FORESTSIDE TOWNHOUSES

TENDER ADDENDUM # 3

Date: January 31st, 2020

JAP Project No: 19066

Job No: 19066 Sheet No: S-102B

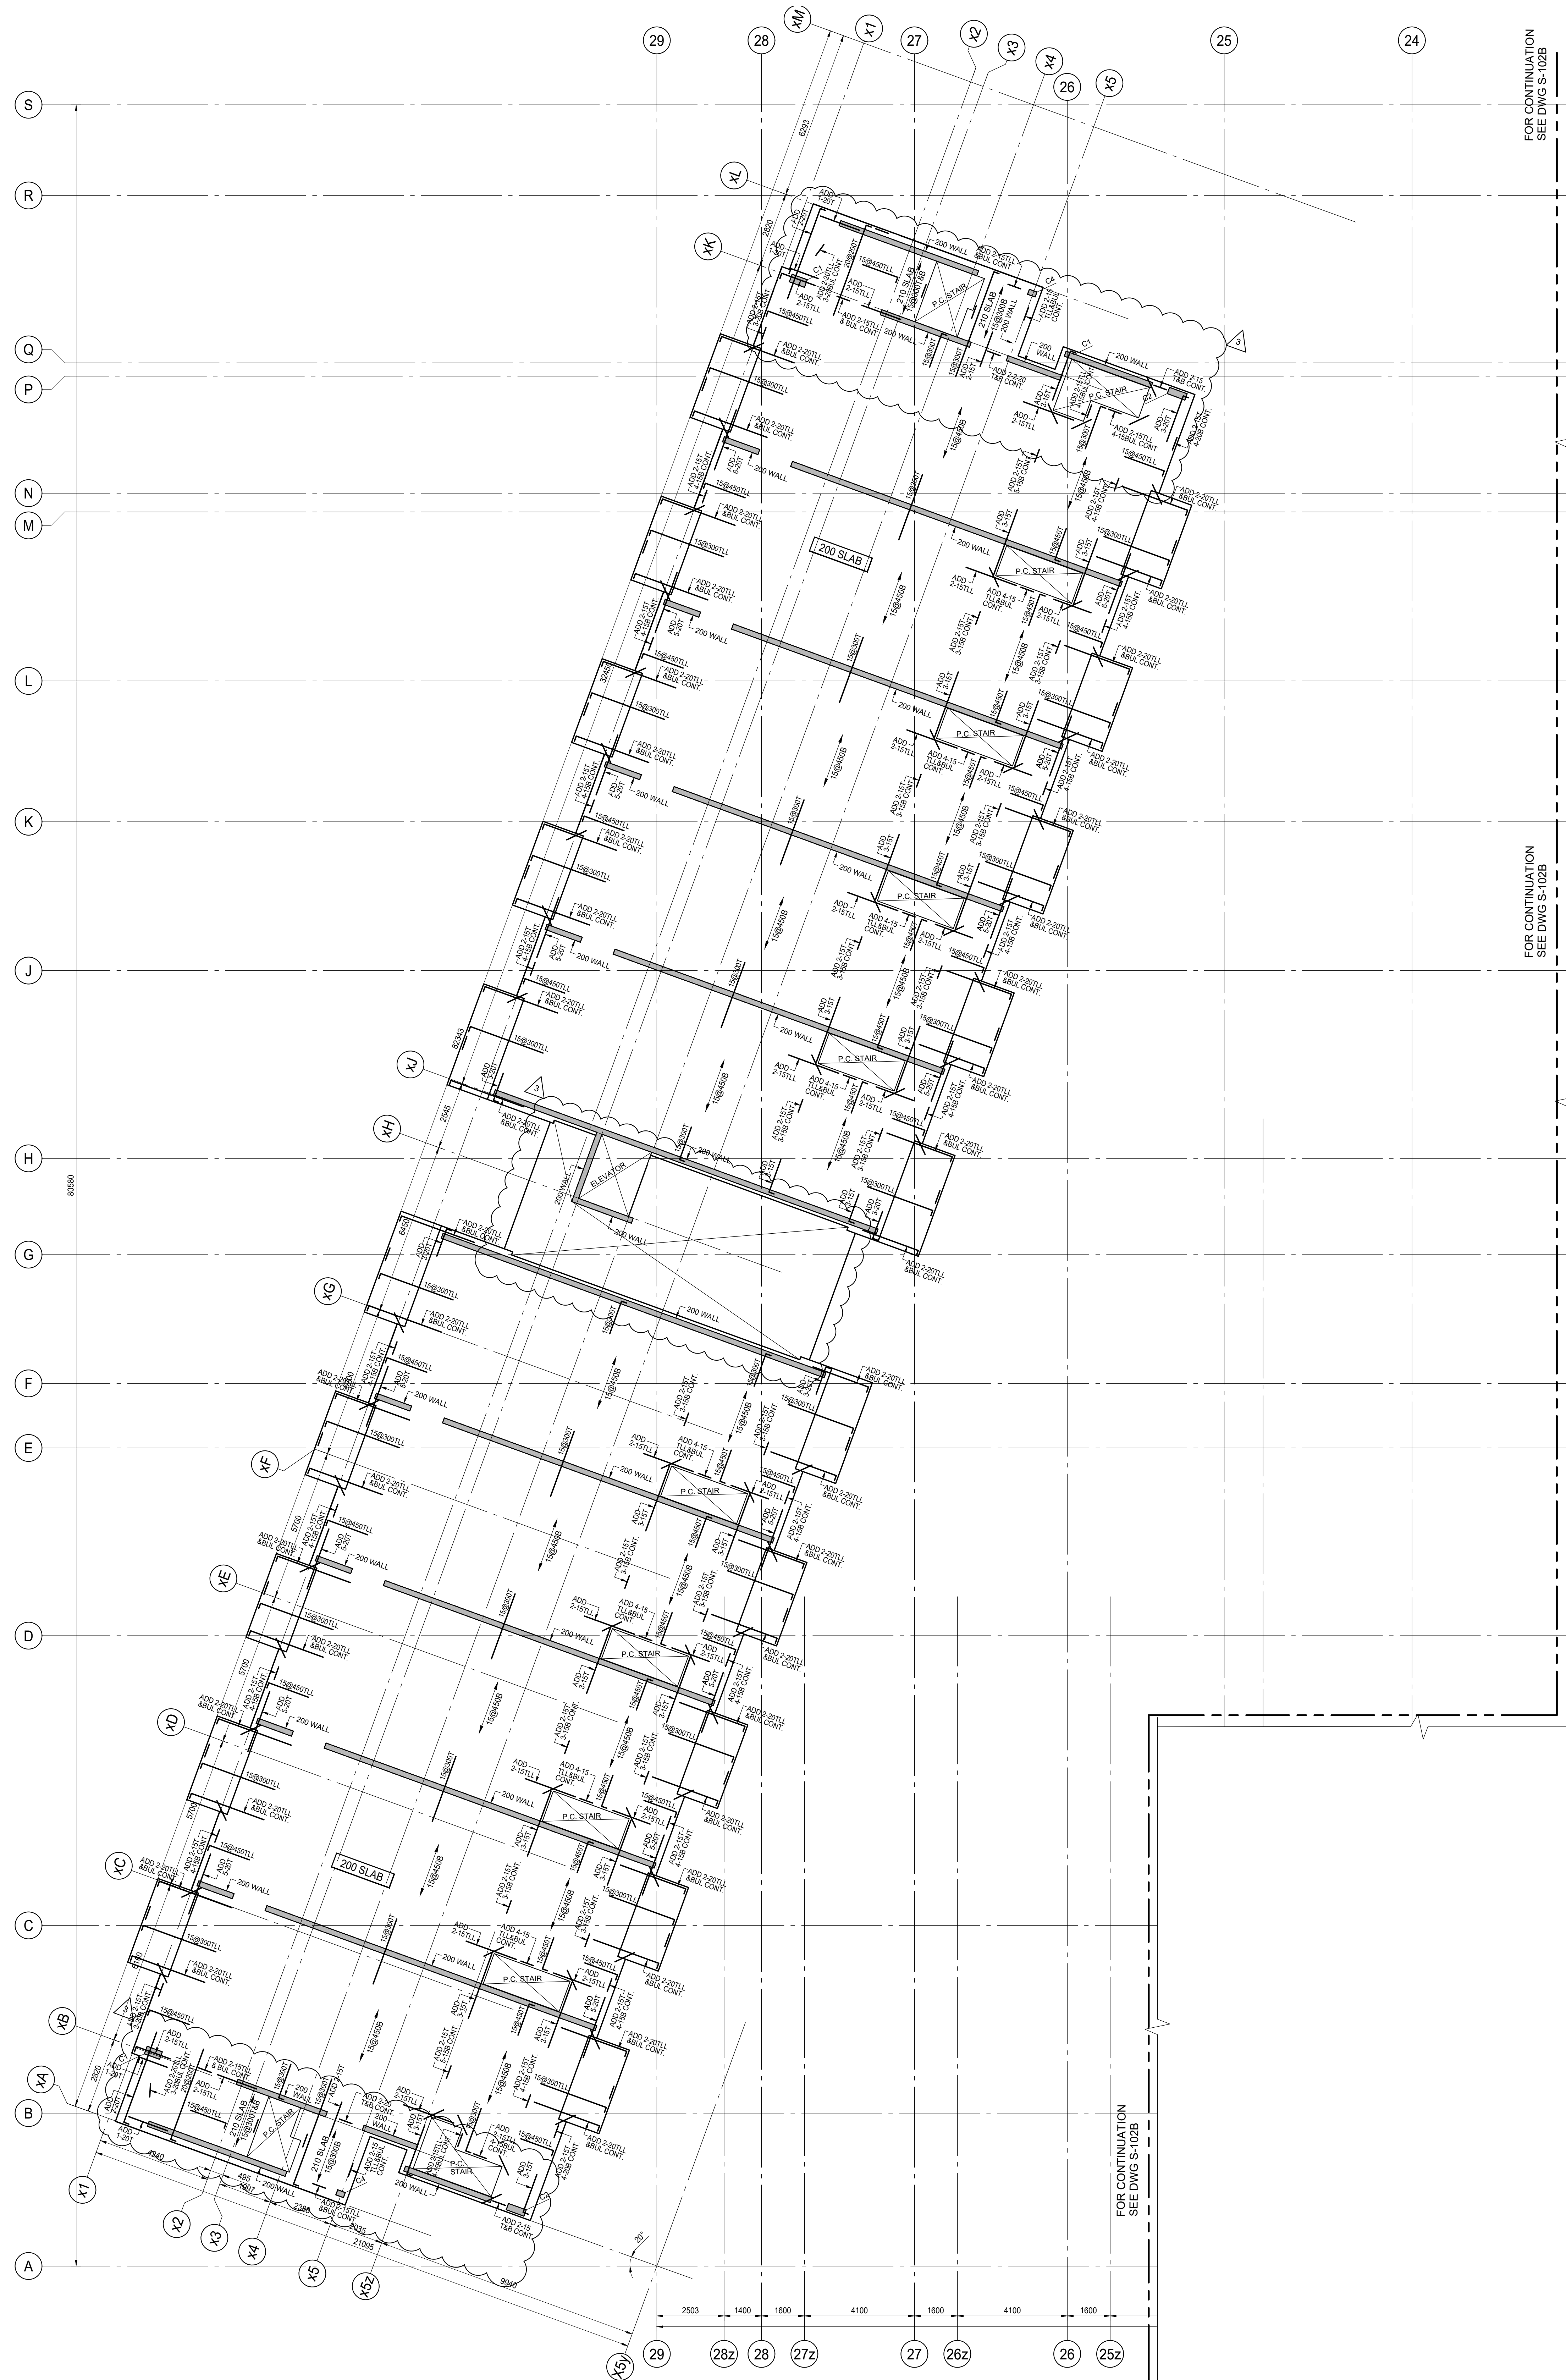
1.2 **Refer to Drawing S-102A & B "GROUND FLOOR"**

- e) Stud rail details 1 & 2 S-102A added to replace column capitals.
- f) Structure (column and walls) altered at client request.

Job No: 19066 Sheet No: S-103A

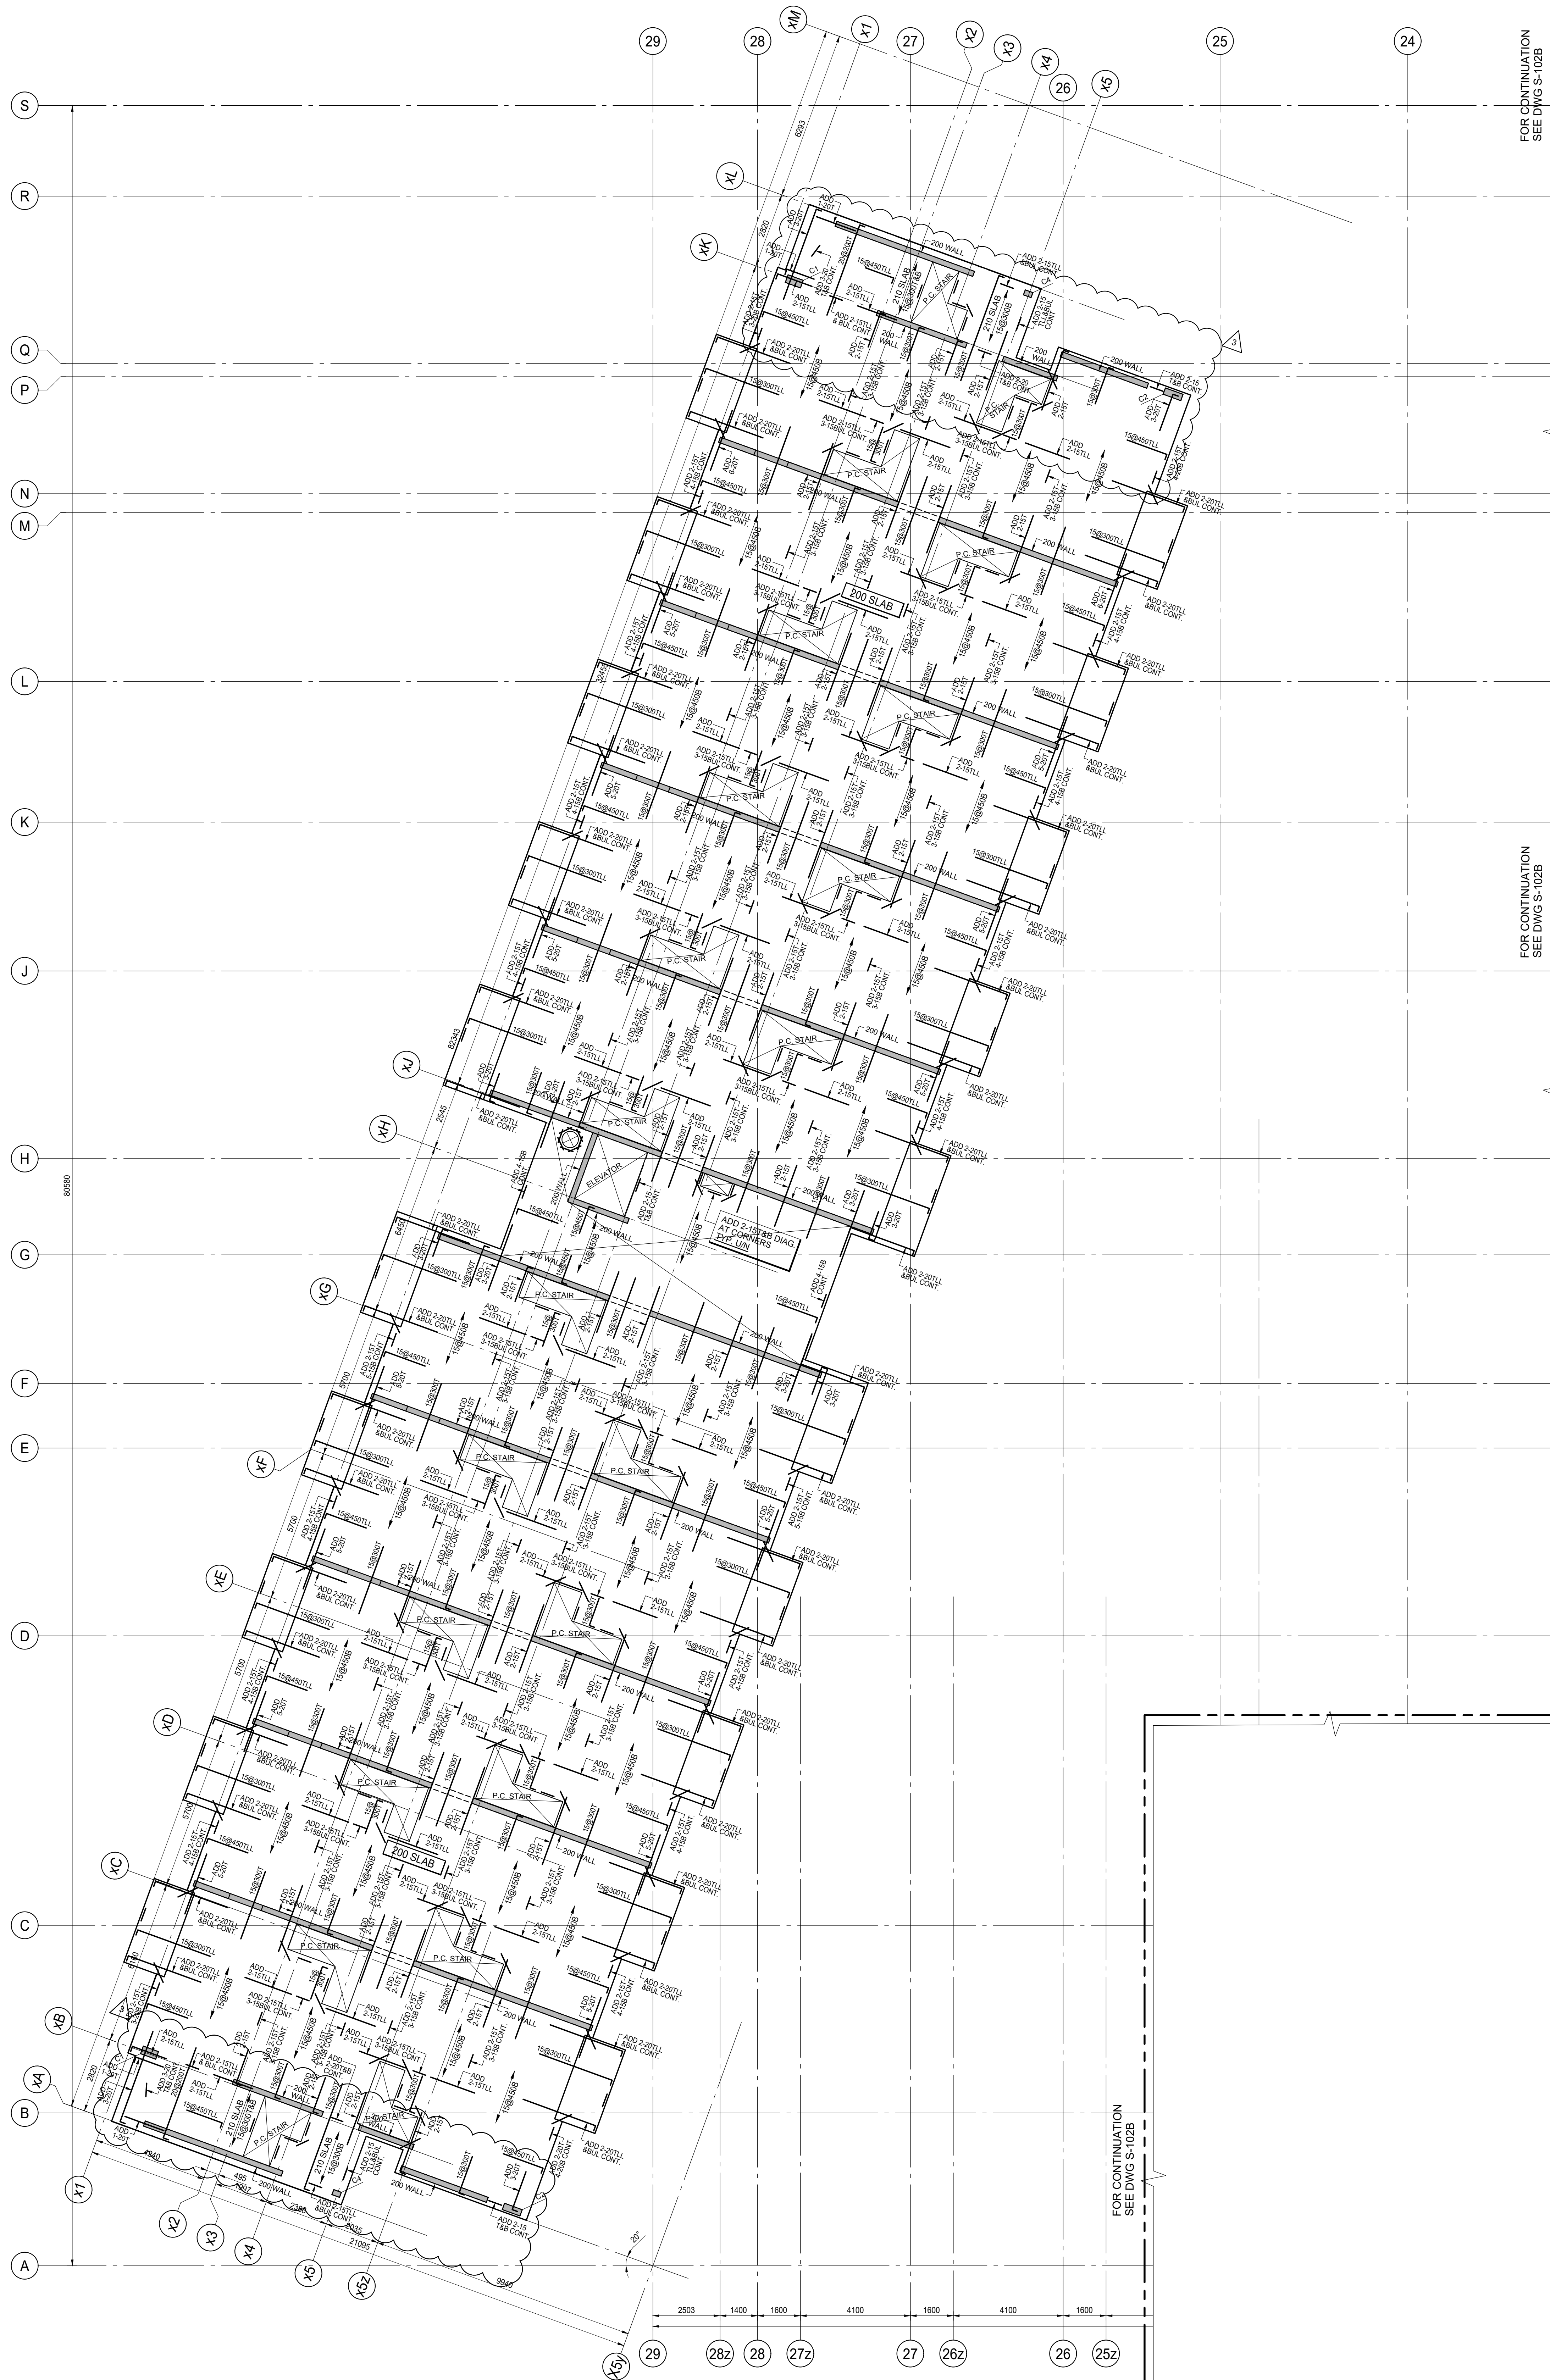
1.3 **Refer to Drawing S-103A & B "2ND FLOOR FRAMING PLAN"**

- g) Structure (column and walls) altered at client request.
- h) Reinforcement at altered structure locations updated.
- i) Slab between individual blocks removed at this level.

Date Plotted	Date :
	Jan 31 2020
Drawn By: ND	Scale: 1 : 100
Checked By : JW	Revision Number:
Job No : 19066	Sheet No: S-104B

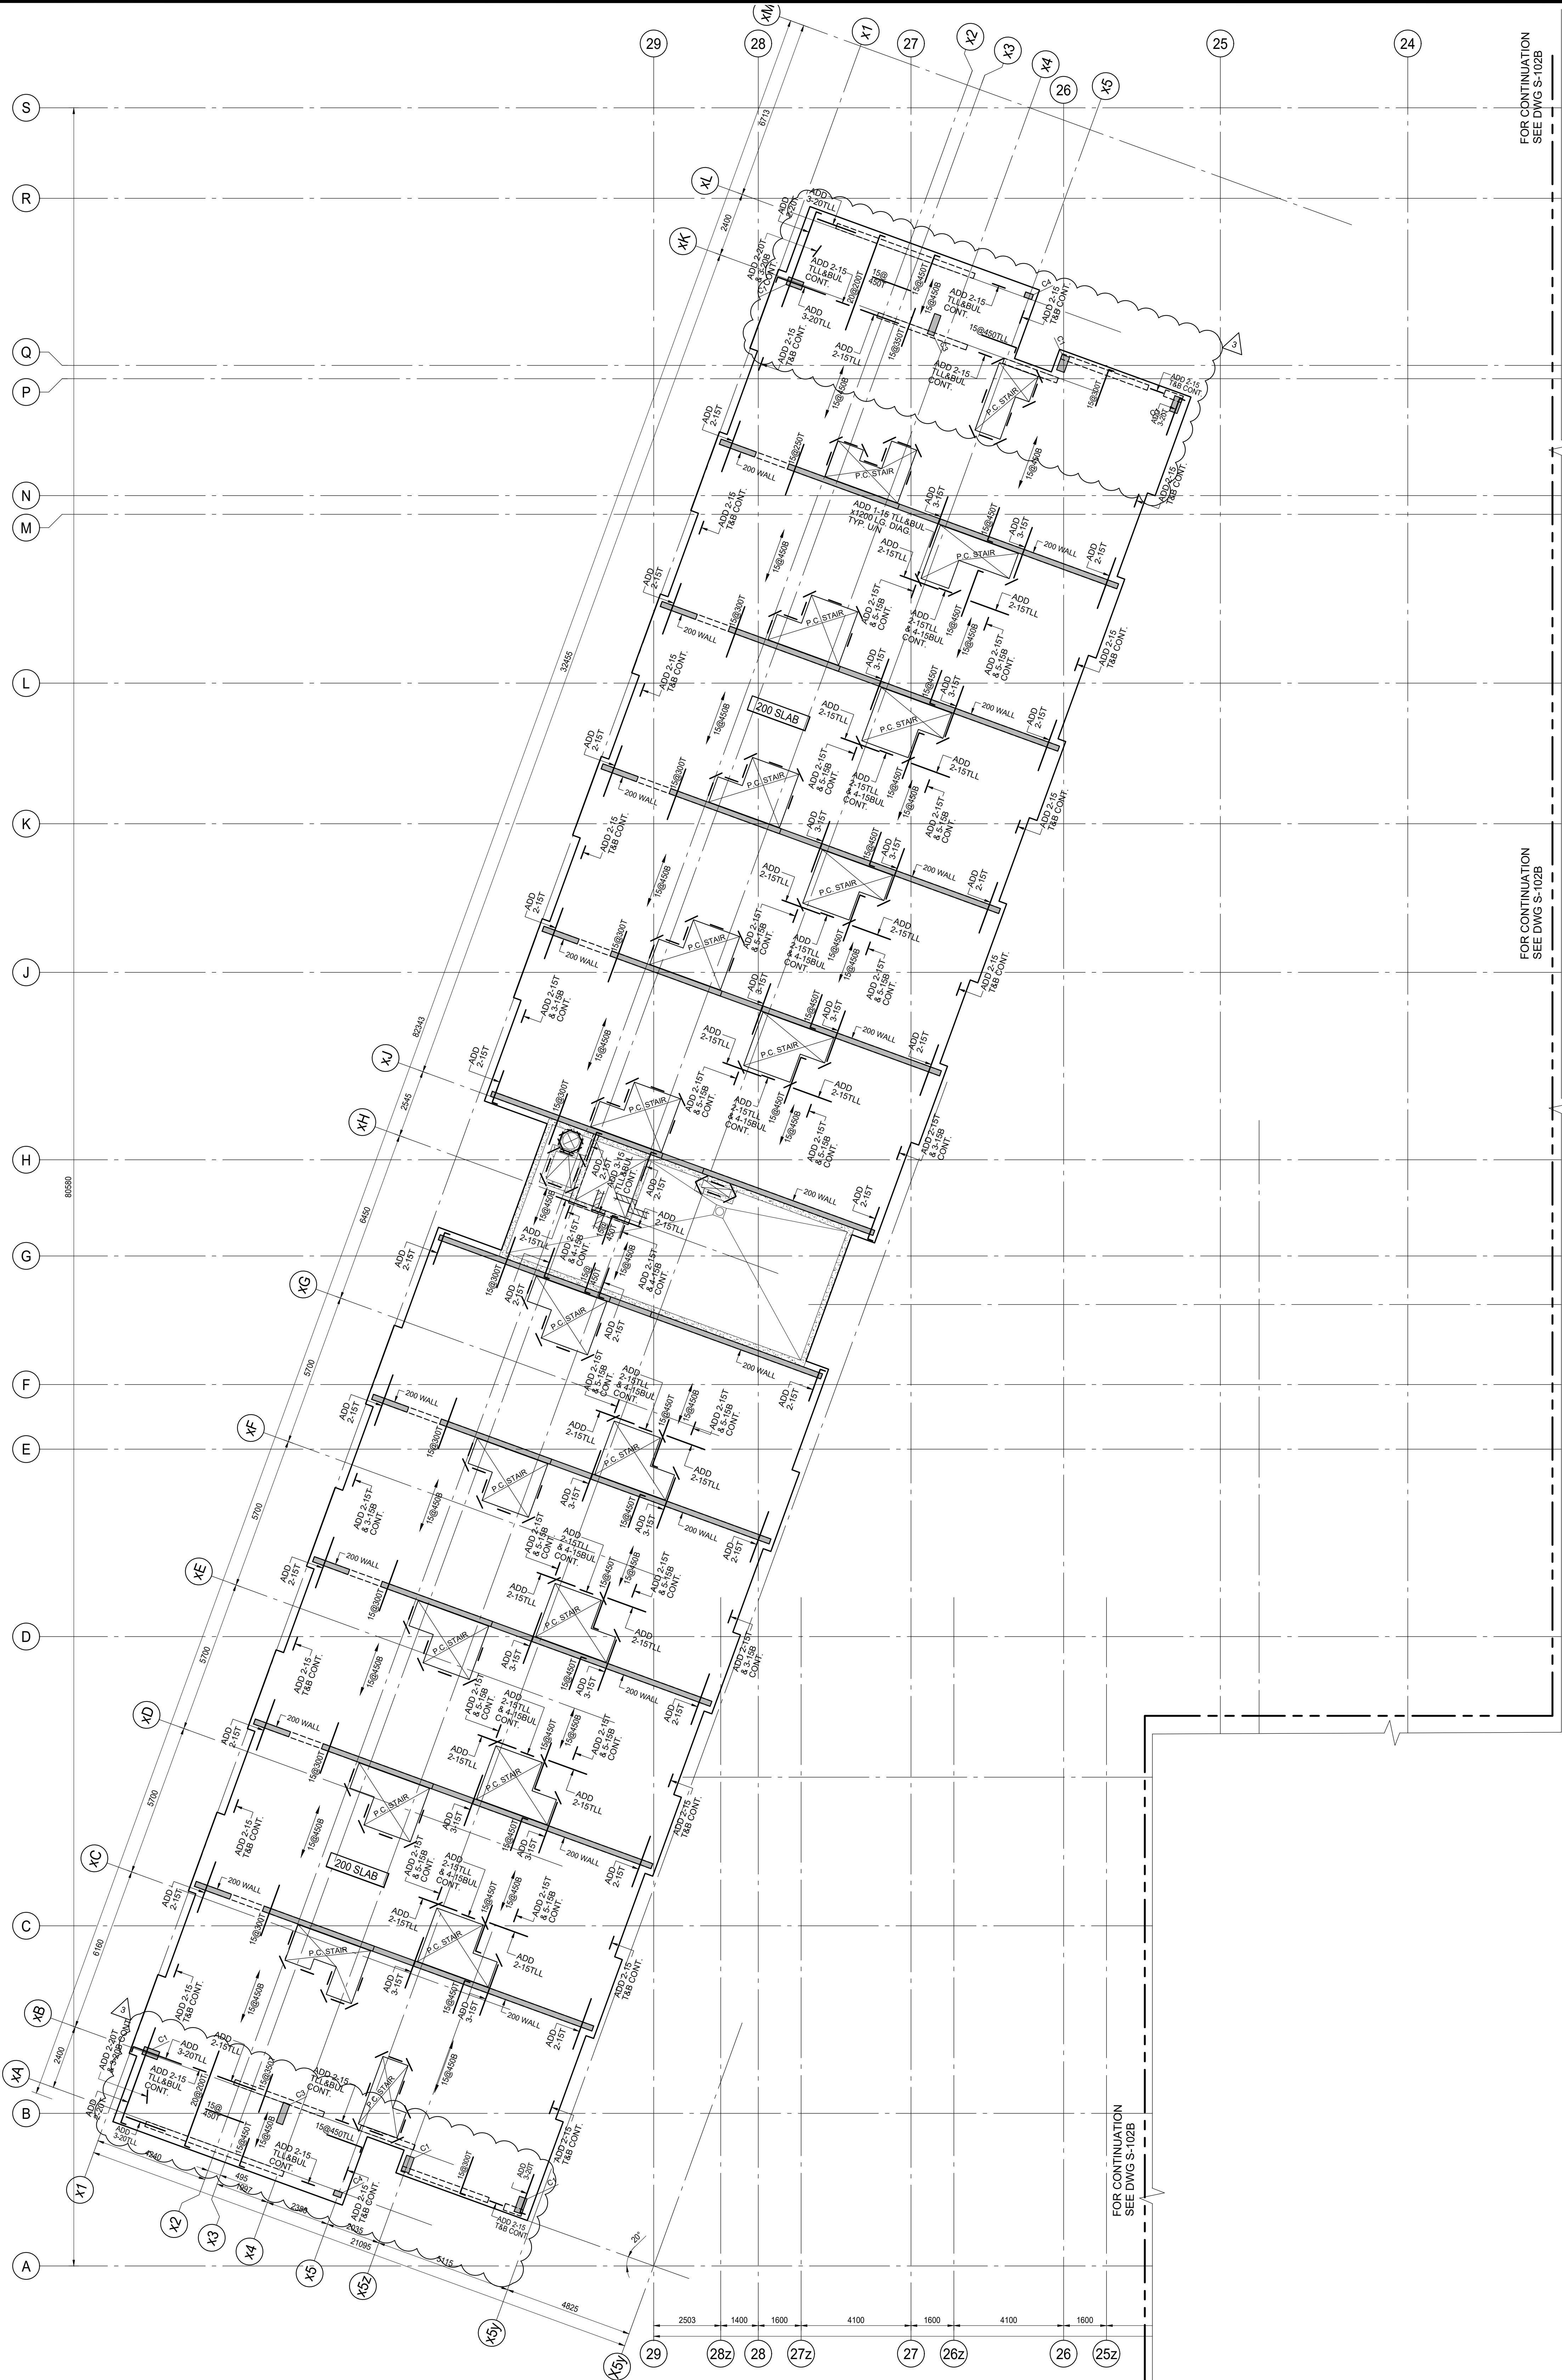
1.4 **Refer to Drawing S-104A & B "3RD FLOOR FRAMING PLAN"**

- j) Structure (column and walls) altered at client request.
- k) Reinforcement at altered structure locations updated.
